The DRAFT 2022 Annual Report and Work Plan (“ARWP”),¹ dated and received August 1, 2022, documents the substantial effort by State Parks to understand and control windblown dust emissions from the Oceano Dunes State Vehicular Recreation Area (“ODSVRA”) over the last year. Between August 1, 2021, and July 31, 2022, State Parks installed 90.0 new acres of dust controls, converted 53.1 acres of existing temporary controls to permanent controls, and maintained existing vegetation plots and wind fence arrays. This is work that was proposed in the 2021 ARWP² approved by the District on October 20, 2021.³

San Luis Obispo County Air Pollution Control District August 23, 2022 Comments on the
DRAFT 2022 Annual Report and Work Plan dated August 1, 2022

Figure 1: ARWP Figure 2-14

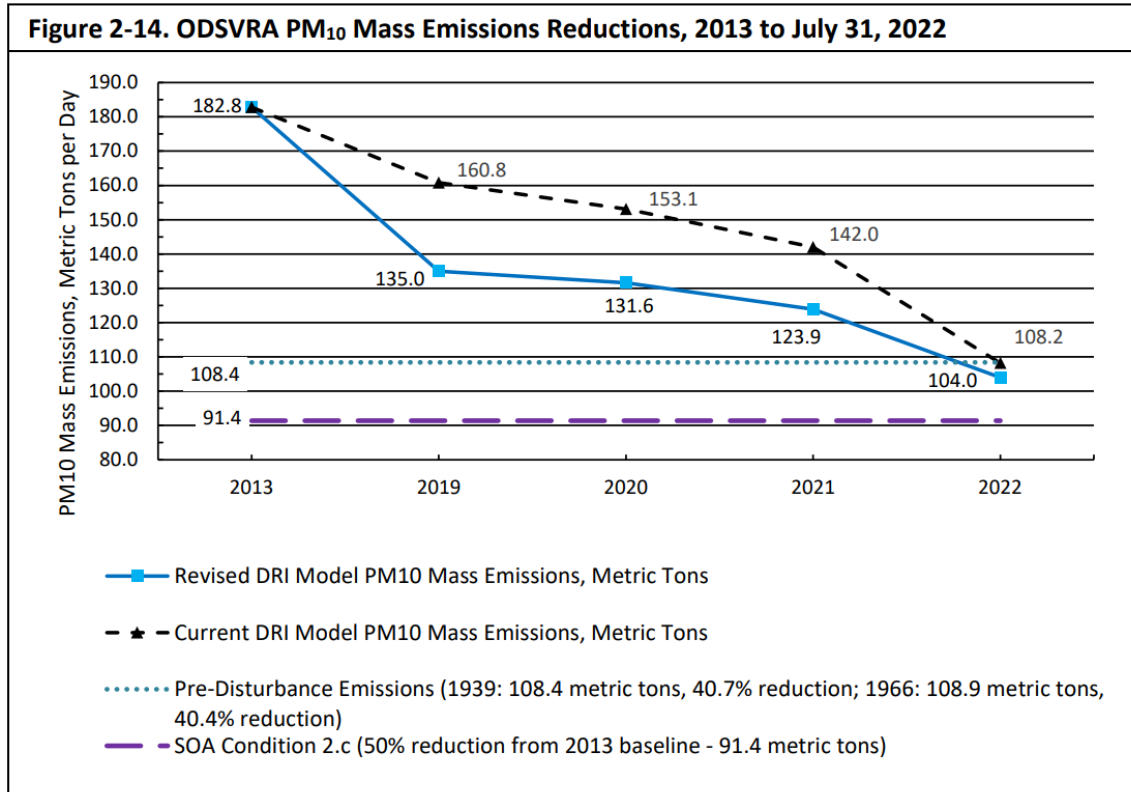
As shown in ARWP Figure 2-14, these changes do not affect emissions for 2013, which are estimated as 182 metric tons per day (tpd) by both models. This is expected as 2013 is the baseline year and the original model (referred to as the “current model” in the figure) and revised models both use the 2013 emissions grid for the baseline, and no dust controls had yet been installed in 2013 which would be affected by the Changes 1 and 2. The effect of the modeling changes on emissions estimates for 2022 will be discussed later. For 2019-2021, the changes dramatically lower the modeled emissions. For example, for 2021, the changes reduce modeled emissions from 142.0 tpd to 123.9 tpd, net difference of 16.1 tpd.

Change 1 should cause the revised model to estimate higher emissions than the original model. Change 2 should decrease emissions slightly, but this is likely to be more than offset by the increased emissions resulting from Change 1. Regarding Change 3—updating the emissions grid to use 2019 PI-SWERL measurements—it is not obvious, a priority, whether this should increase or decrease emissions. Given that the net effect of all three changes is a large decrease in emissions, it stands to reason that this change results in a large decrease in emissions. The question is, “Why?” Is the apparent decrease in riding area emissivity over this time period real? Or does it reflect random variability from year to year or between seasons? Or it is an artifact of local conditions during the PI-SWERL measurement campaigns (e.g., relative humidity or soil moisture)? And if it is real, is this a permanent change that State Parks can guarantee will not be reversed or attenuated in the future? Neither the ARWP nor the SAG report⁶ recommending this change provide any insight into these questions.

We note that the only difference (or at least the most significant difference) between the modeling of 2021 and 2022 is the inclusion of closure of the Plover Exclosure in 2022. As shown ARWP Figure 2-14, this results in a significant decrease in modeled emissions. For the original (“current”) model—represented by the dashed black line in the figure—this change of 33.8 tpd is likely overestimated, as the model assumes 100% elimination of baseline emissions from this area. For the revised model—light blue solid line—the decrease is smaller, as expected: 19.9 tpd, and this may still be an overestimate. If the original (“current”) model was used to model 2022, but with Plover Exclosure

modeled as in the revised model (i.e., assuming emissivity of 50% of 2019 rather than as non-emissive), then estimated mass emissions would be approximately 122.1 tpd.¹¹ This level of emissions fails to attain both the current SOA Section 2.c target (50% reduction or 91.4 tpd; purple dashed line in the figure) and the proposed new target (40.7% reduction or 108.4 tpd; blue dotted line).

- Use the original/“current” model for determining PM₁₀ mass emissions from the ODSVRA, or use a revised model incorporating only Changes 1 and 2. The latter is the District’s preferred option, though we recognize there may not be time to implement such a model within the timeframe of this ARWP cycle.
